Access Compliance Report

Public Rights-of-Way

Intersection ID: 44171	Main Street: BELLEGARDE_DR	Cross Street: REA_RD	Location: SE
ADA ID: 53E343006378	Ramp Type: Perp	Initial Pass/Fail: Fail	Overall Compliance: No
		Severity Score: 22.5

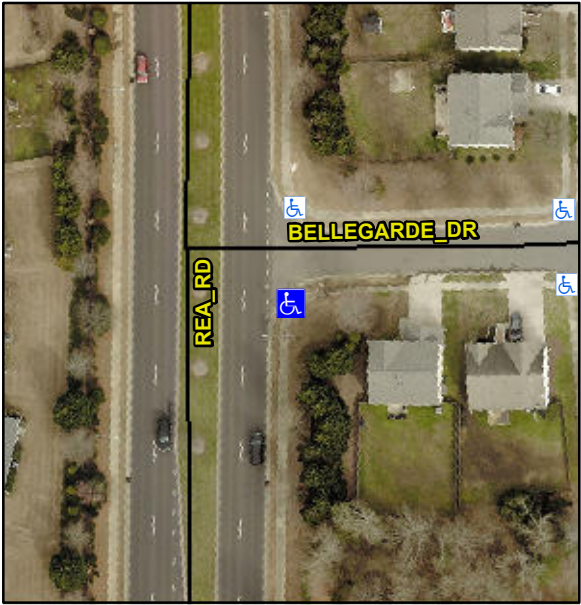
Codes/Mitigation Info/Possible Solution			Field Measurements/Component Compliance		
	Possible Solutions:		Compliance	Description	Data
	Remove & Replace Entire Ramp.		No	Ramp Length (in)	44.0
			No	Ramp Width (in)	42.0
			N/A	Flare Type LT	N/A
			N/A	Flare Slope LT (%)	N/A
			N/A	Flare Traversable LT?	N/A
			N/A	Landing Length (in)	N/A
			N/A	Landing Width (in)	N/A
			N/A	Landing Slope (%)	N/A
			N/A	Landing X Slope (%)	N/A
			N/A	Landing Curb? (Y/N)	N/A
			N/A	Shared Landing?	N/A
			N/A	Gutter Ponding?	N/A
			N/A	Gutter Lip Ht (in)	N/A
			N/A	Painted X Walk1?	No
			N/A	X Walk 1 Direction	To N
			N/A	X Walk 1 Width (in)	N/A

0.4	X Walk 1 Slope (%)	
			0.4	X Walk 1 X Slope (%)	
			N/A	Ramp inside XWalk1?	N/A
<p>Surveyor Notes:</p> <p>N/A</p> <p>PROW/ADA:</p> <p>Not Found, R304.5.1, R304.2.2, R304.5.3</p>			N/A	Flare Type RT	N/A
			N/A	Flare Slope RT (%)	N/A
			N/A	Flare Traversable RT?	N/A
			N/A	DWS Provided?	N/A
			N/A	DWS Contrast?	N/A
			N/A	DWS Length (in)	N/A
			N/A	DWS Full Width?	N/A
			N/A	DWS Offset (in)	N/A
			N/A	Gutter Slope (%)	N/A
			N/A	Gutter X Slope (%)	N/A
			N/A	Painted X Walk2?	N/A
			N/A	X Walk 2 Direction	N/A
			N/A	X Walk 2 Width (in)	N/A
			N/A	X Walk 2 Slope (%)	N/A
			N/A	X Walk 2 X Slope (%)	N/A
			N/A	Ramp inside XWalk2?	N/A
			N/A	Clear Space?	N/A
			N/A	Clear Space to XWalk (in)	N/A
			N/A	Storm Grate/Utility Hazard?	N/A
			N/A	Storm Grate/Utility Type	N/A
			N/A	Surface Condition? (G/P)	Good
Total Cost:		\$ 1850.00
